There are several corrections needed to this schematic and some comments.

MOOG MUSIC INC.
SCHEMATIC, 914 FIXED FILTER BANK
993-041820

FIGURE 20. FIXED FILTER MODEL 914

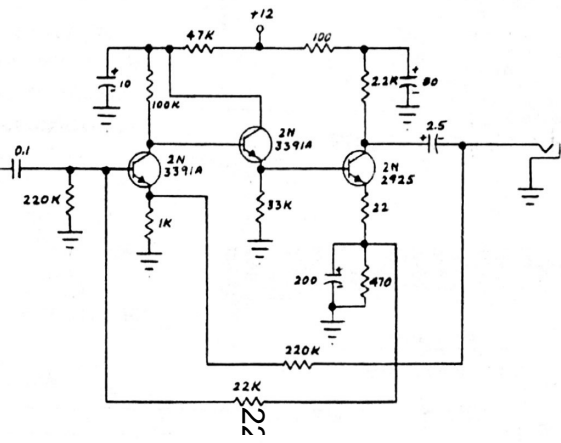
8.2k all BP cells. 5.6k works, too.

- There is a 22k feedback resistor in the output amplifier. It should be 220k.
- The first inductor in the 350Hz cell should be 1.2H. I believe the individual who copied this schematic misread the "H" as a "4".

- The resistors in the LP cell appear to be 10k in photos of real 914 modules I've seen.
- The capacitors in the LP section should therefore be about 1.2-1.5uF. I used 1.22uF, combination of 1.0uF and 0.22uF and obtained a close match to the Moog response. The target cutoff is about 88Hz.

- The input resistor in the LP should be 4.7k. I can be a little bigger or smaller if needed to help with trimming.
- The trimmer in the LP should be 25k to give proper adjustment. Bigger is ok because it is only a variable resistor, but reduces precision. The trimmer and input resistor can be adjusted as needed.

- The input resistors to all the BP cells should be 4.7k not 47k. This is consistent with the photos I've seen of real 914s.
- The input trimmers for all the BP cells should be 25k. 100k works but reduces precision in trimming. These trimmers adjust the overall "Q" for the BP cells. Increasing "Q" (increasing the resistance) reduces the gain. In my builds, a 25k with the 4.7k input resistor gives me a trim "sweet spot" at about midpoint on a 25k trimmer for most cells.

- There is a resistor missing on all the BP cells which is in parallel with the second inductor/capacitor pair. This resistor sets the "Q" for the second cell. Photos of two different 914 modules show this resistor as 8.2k or 47k respectively. The 8.2k works well in practice as does a 5.6k. The 47k sets the "Q" too high. The 8.2k sets it in theory to about 4.0, the 5.6k sets it to about 3.0, the 47k sets it to about 25. I built my real inductor using 8.2k and my GIC with 5.6k. Both give good matches to the Moog published response.

- There is a resistor missing on the HP cell which should be in parallel with the second inductor/capacitor pair, similar to the BP cells. In the HP cell based on the photos, this appears to be a 10k resistor.

- The capacitors in the HP cell, C27 and C28, work well at 2nF for inductors close to 150mH. I used two 1nF capacitors. The target cutoff is about 7kHz.

- For clarification, the input resistor for the HP cell should be 4.7k as shown in this schematic.
- The input trimmer for the HP cell should be 10k.
